REVIEW OF ENVIRONMENTAL INVESTIGATIONS
AT JOHNSON CONTROLS'
FOWLerville, MICHIGAN, SITE

January 9, 2002

Disposal Safety Incorporated

AFL-CIO
815 Sixteenth St. NW
Washington, DC 20006

JCI'S TCE PLUME INTERPRETATION

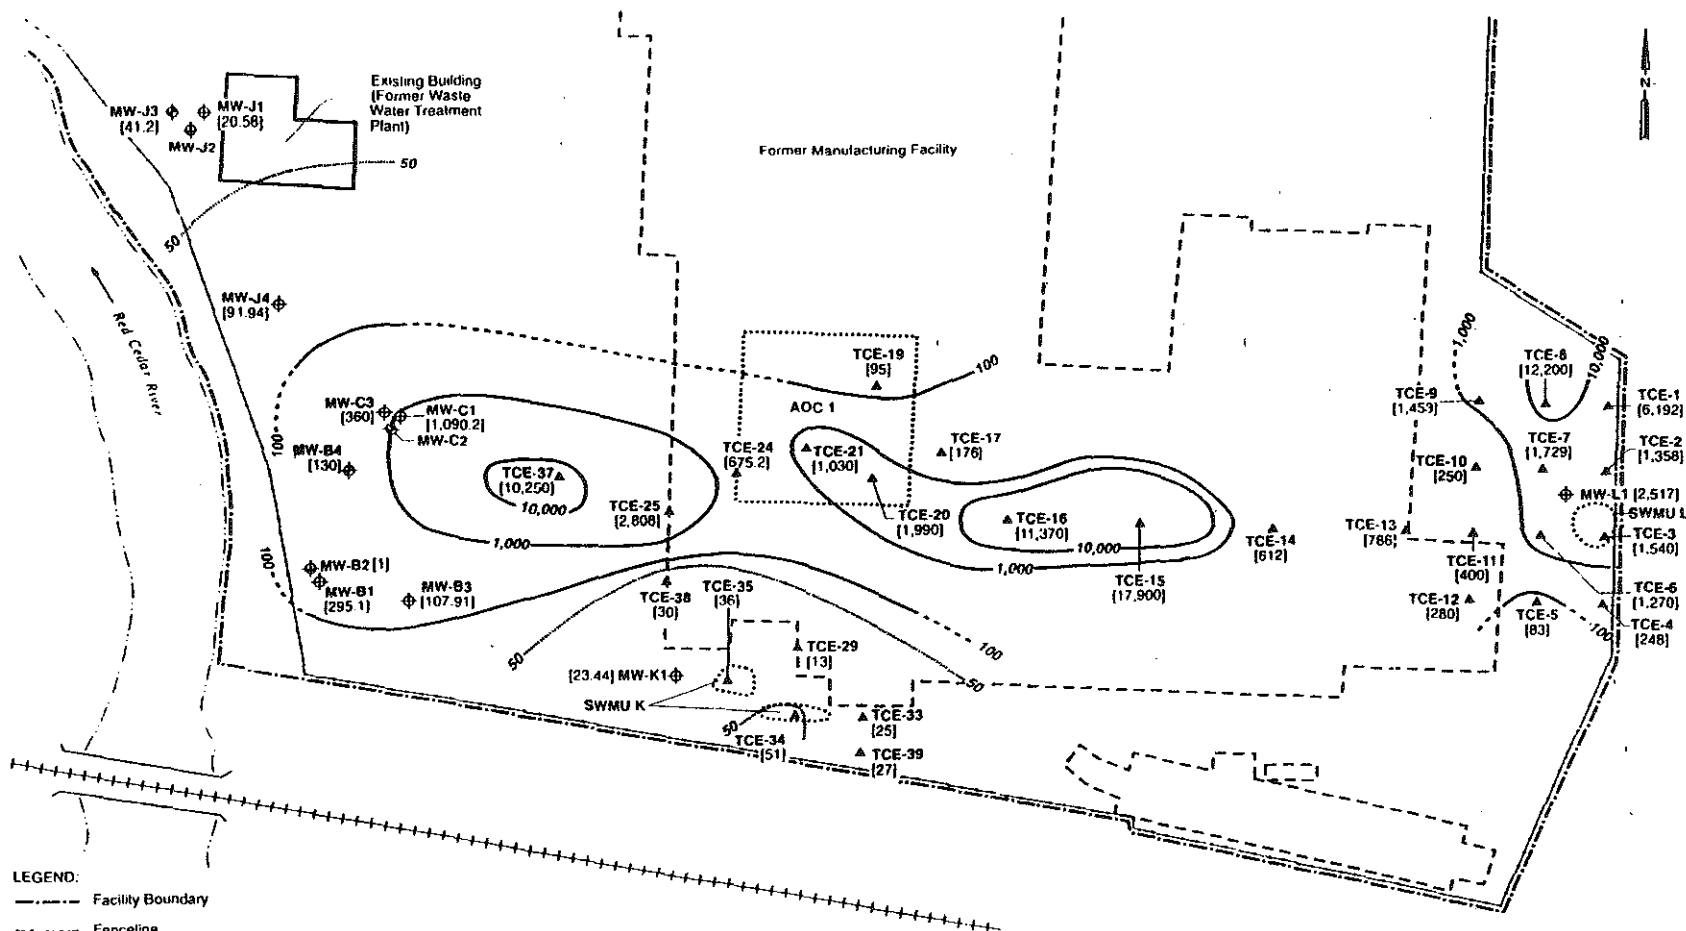
JCI's interpretation of the horizontal and vertical distribution of TCE, its breakdown products (DCE, vinyl chloride) and other solvents is shown in Figures 3 and 4, reproduced from the Phase III RFI report. The plume is depicted as containing at least three large "hot spots" — areas of shallow ground-water contamination in which VOC concentrations exceed 10,000 ppb — along the flow path of the plume. The hottest is the central one, in which VOC concentrations total nearly 18,000 ppb. The three hot spots are embedded in what appears to be a roughly continuous spine of high concentrations along the longitudinal axis of the plume.

- The contaminant plume does not display "demonstrated attenuation away from the source area." The plume is continuous across the site, with maximum VOC concentrations roughly the same in the eastern (12,200 ppb), central (17,900 ppb), and western (10,250 ppb) portions of the plume. JCI's depiction of the plume as three distinct hotspots is not sufficiently justified by the data. For example, there are no data points to justify the closed concentration contours drawn north of TCE-15 and west of TCE-9.

- Johnson Controls drew Figure 5-3 of the Phase III RFI report (our Figure 3) in a way that suggests that little VOC contamination reaches the river. This is misleading. Wells as close as 50 feet from the river contain hundreds of ppb of VOCs, including vinyl chloride. There is little support for drawing, even tentatively, a 100 ppb concentration contour in front of the river.

In Figure 5 we have redrawn JCI's plume map in a way that we believe better conforms to the chemical and hydraulic data. We have opened the 1000 ppb contour north of TCE-9 and TCE-15, and extended the 100 ppb contour to the river.
